Determination 2016/058

Dispute over the requirement for fire door signage to hotel suites at 124 Devon Street West, New Plymouth

Summary

Figure 1: Drawing showing suites, corridor, and fire separations

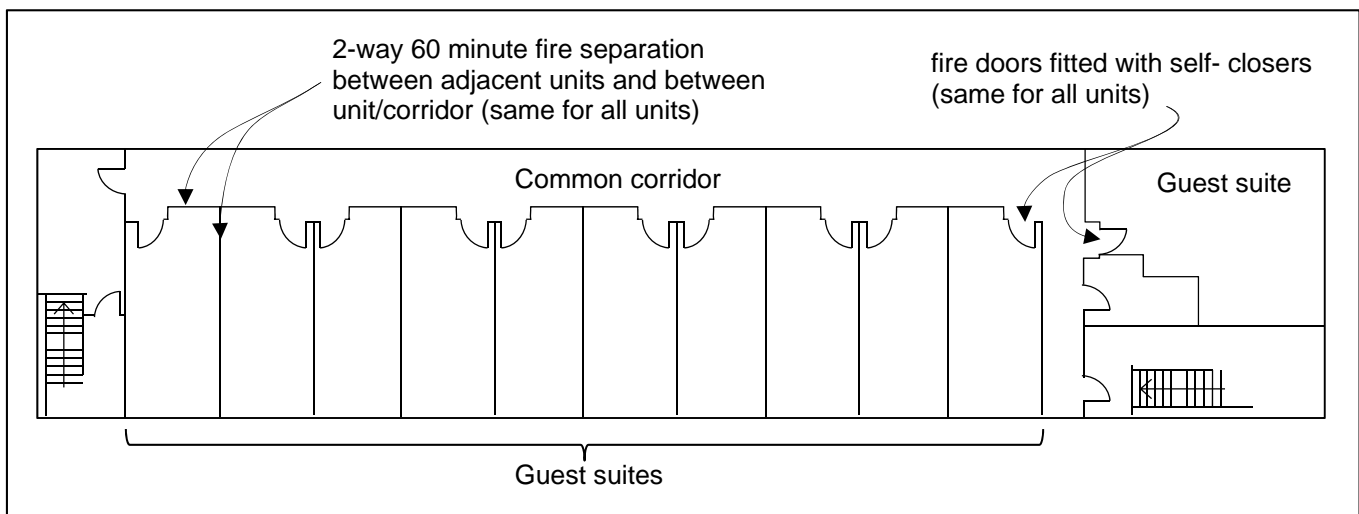
- 5.2.2 I infer from the drawing references to Acceptable Solutions C/AS2 and C/AS4 that compliance with the fire safety requirements for the guest suites has been based on the Acceptable Solution C/AS2, and that the fire doors are provided as part of the means of complying with C/AS2.

- 5.3.1 The drawing showing the location of fire separations describes each suite as being its own fire cell, with a fire-rated door leading to the common corridor. The fire doors are safety features that assist in reducing the spread of smoke and fire to other parts of the building and contribute to a safe means of escape from fire.

- 5.3.3 I have taken the potential hazard in this case to be the exposure of building occupants in the escape route, ie the corridor, to products of combustion (smoke and heat) originating from an attached fire cell (guest suite).

In accordance with section 188 of the Building Act 2004, I hereby determine that the fire doors separating the guest room/suites from the corridor at 124 Devon Street West, New Plymouth, do not require notices advising to keep them shut to be fixed to the door in order to comply with the Building Code Clause F8 Signs.
